# Questions & Answers

## NEC Fuel Dispensing Project

S-IZ100-12-R-0011

February 12, 2012

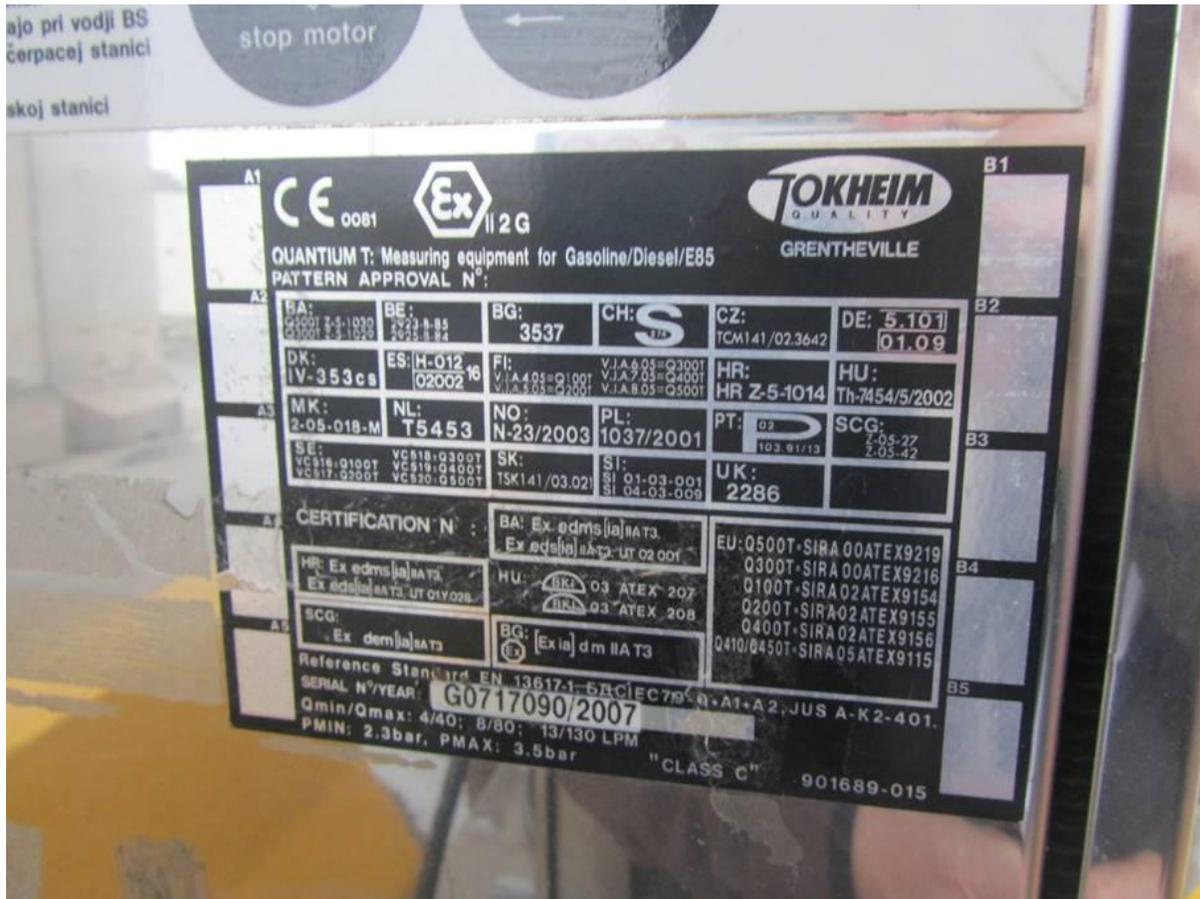
Question: Would you please provide the Manufacturer Brand name and MFR model for the existing fuel dispensing pumps.

Answer: The existing dispensing pumps are manufactured by Tokheim. From the pump nameplate: Quantum T: Measuring equipment for Gasoline/Diesel/E85. Serial number: G0717090, installed 2007. Photo below.
